VILLAGE OF BARTLETT

COMMITTEE AGENDA

JULY 18, 2023

Item Name Hawk Hollow Middle School Committee or Board Committee

Project Number:
 220105
 Issue Date:
 MAY 26, 2023
 Drawn By:
 JES
 Sheet Title:
 FENCE SECTIONS
 Sheet Number:
 EX1

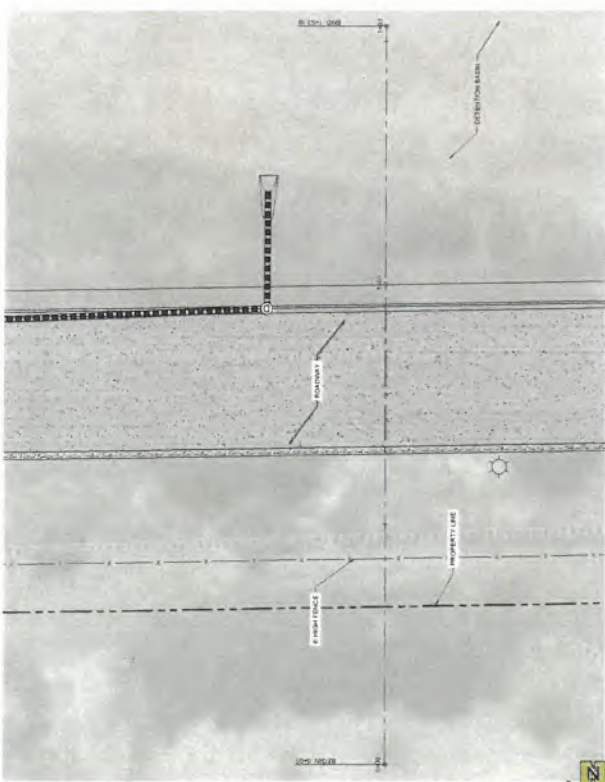
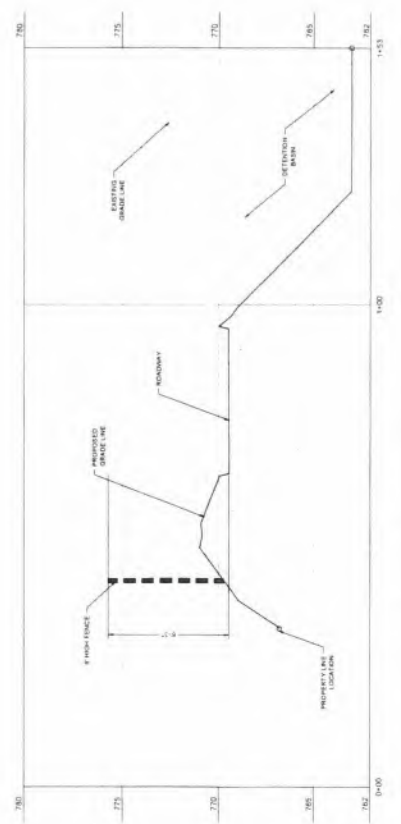
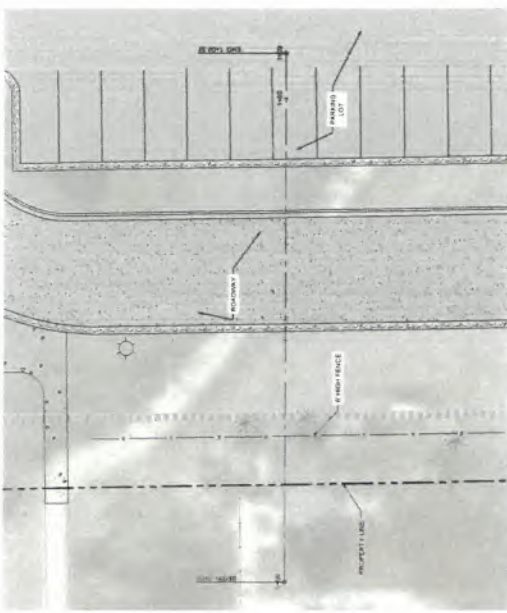
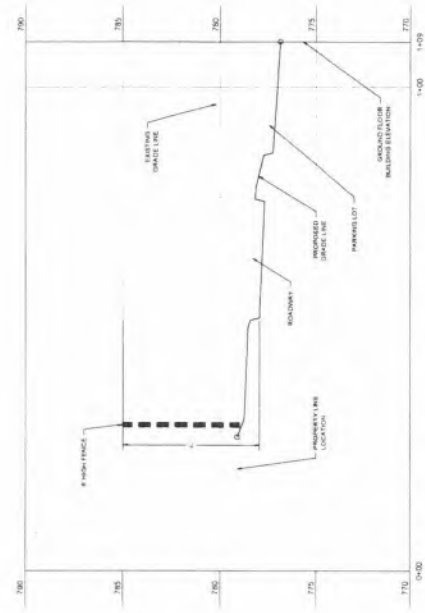
- P. The petitioner shall add screening at the end of Winston Lane to the end of the fence as far east as possible;
 - Q. The petitioner shall provide a safety monitor (crossing guard) at the proposed north entrance.

3. After the P & Z Commission meeting, the applicant has agreed to having a safety monitor (crossing guard) at the north entrance and has submitted the following which are attached:
 - i. Fence section exhibit EX1 in which the fence has been moved further south and is now eight (8) feet from north property line (previously 5 feet);
 - ii. Landscape Plan L2.0 which includes the addition of seven (7) Black Hill Spruce trees at the south end of Winston Drive to provide additional screening of the parking lot

Figure 9
Traffic Management Plan

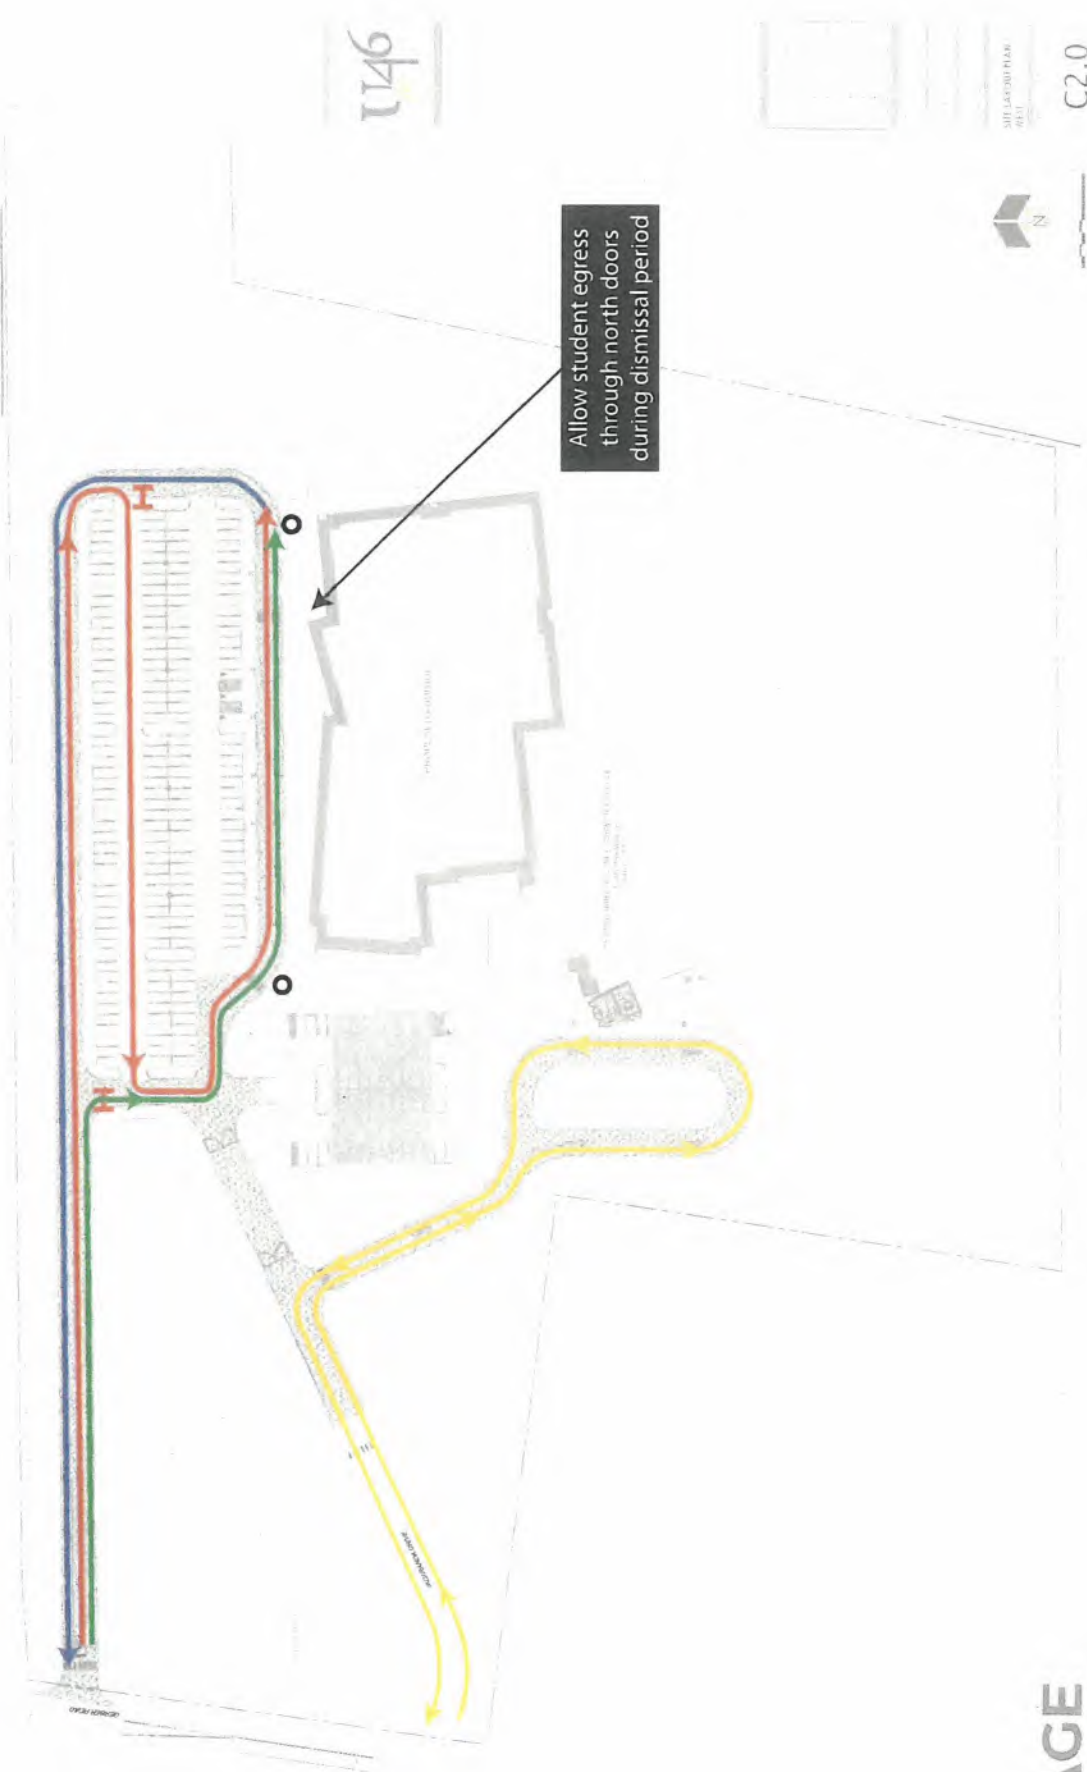
- Within the site, the easternmost parking lot should be actively managed with temporary traffic control and personnel such that pick-up traffic utilizes parking area drive aisles for queue storage, as outlined on **Figure 9**.

Client:	Savoury	Project:	Exterior Sign	Revision:	3
Address:	782 W. Bartlett Road, Bartlett, IL 60103			Date:	5/18/2023

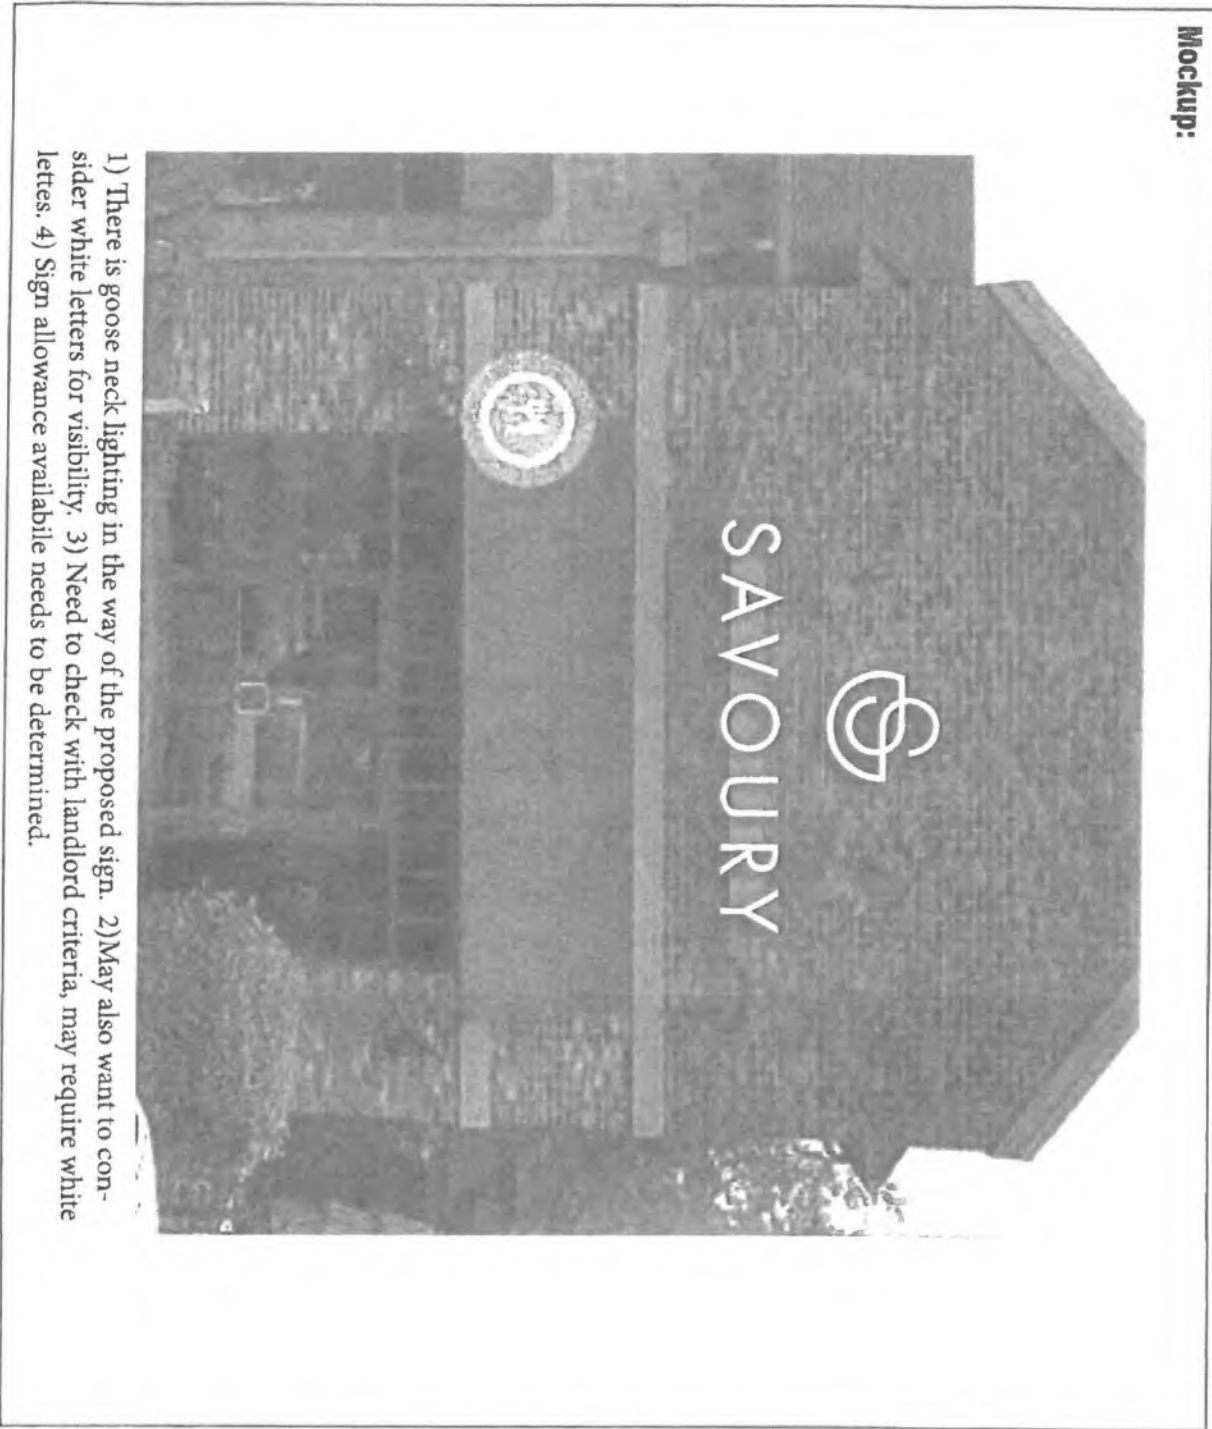
1) There is goose neck lighting in the way of the proposed sign. 2) May also want to consider white letters for visibility. 3) Need to check with landlord criteria, may require white letters. 4) Sign allowance available needs to be determined.
